Addendum No. 1
Solicitation 25-99833
Chambersburg Water Main Replacement

This addendum serves to notify all bidders of the following changes to the solicitation documents:

CHAMBERSBURG AVE WATER MAIN

TABULATIONS

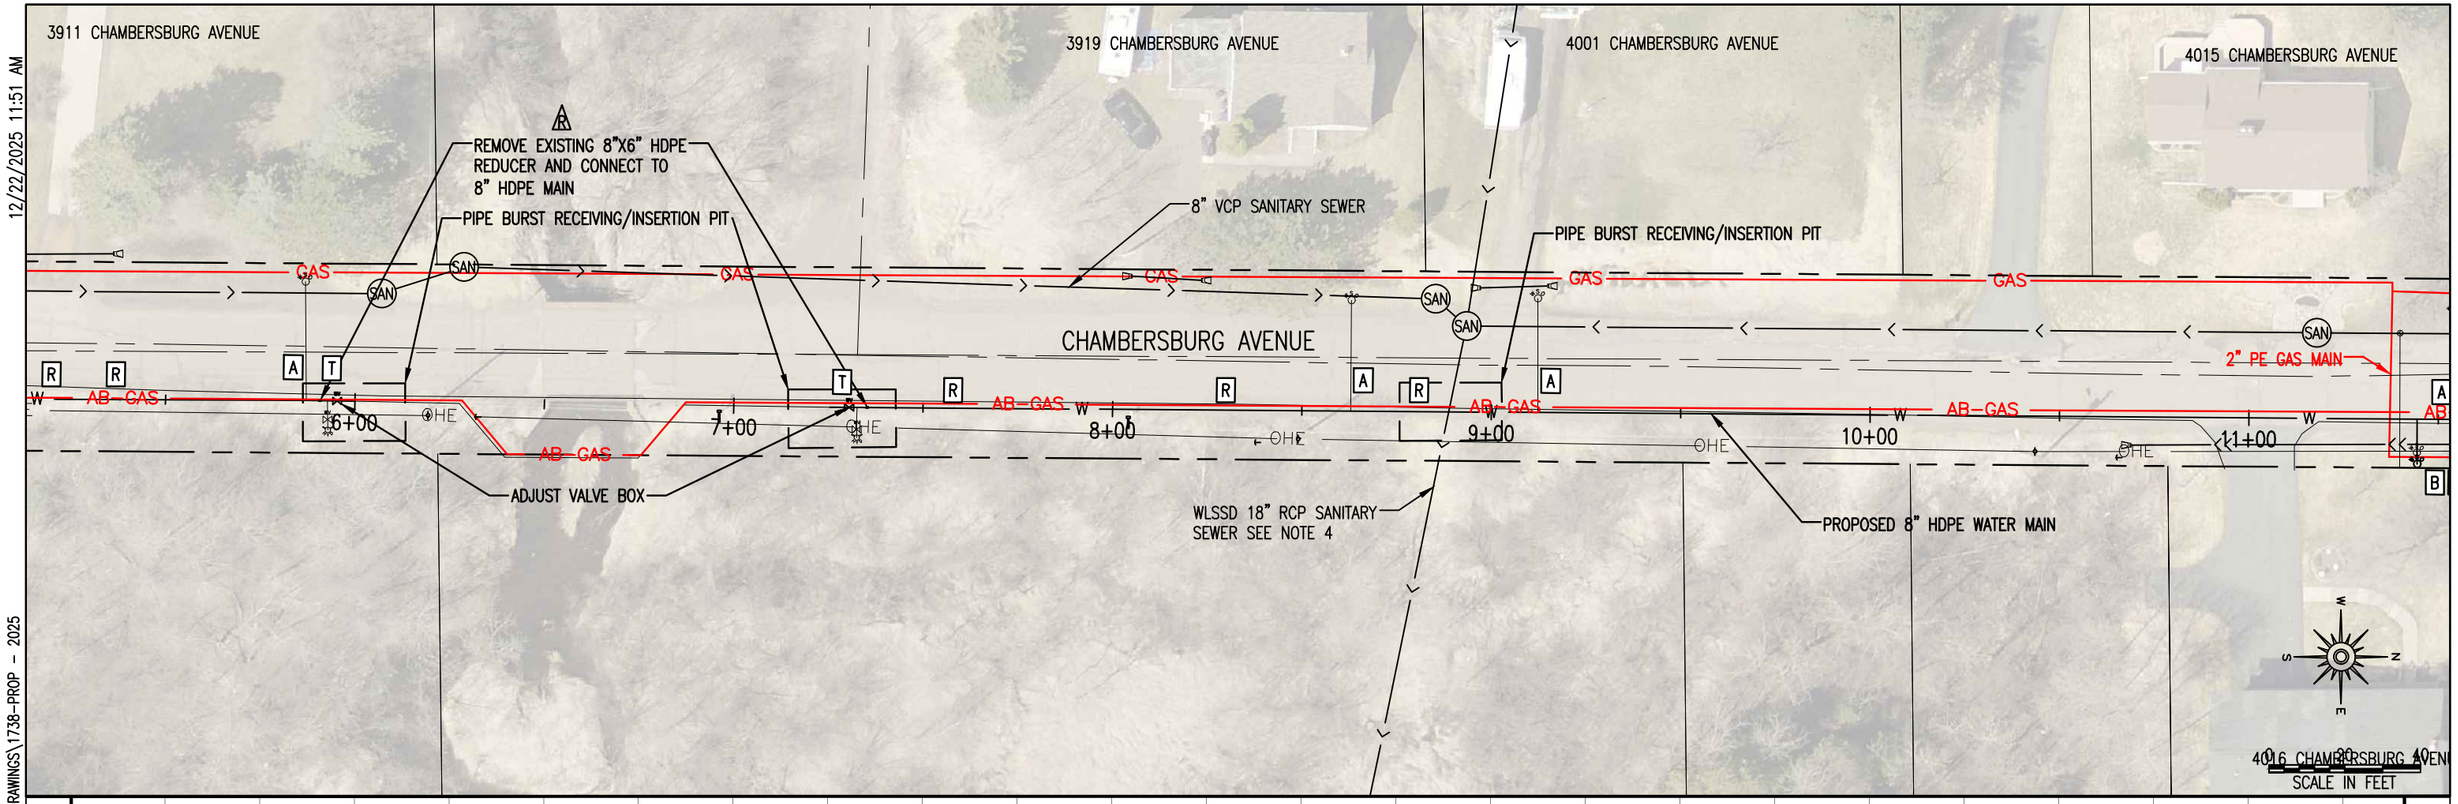
1. **REPLACE** Plan Sheet 2, Plan Sheet 3 and Plan Sheet 9 with the revised attached plan sheets dated 12-22-2025
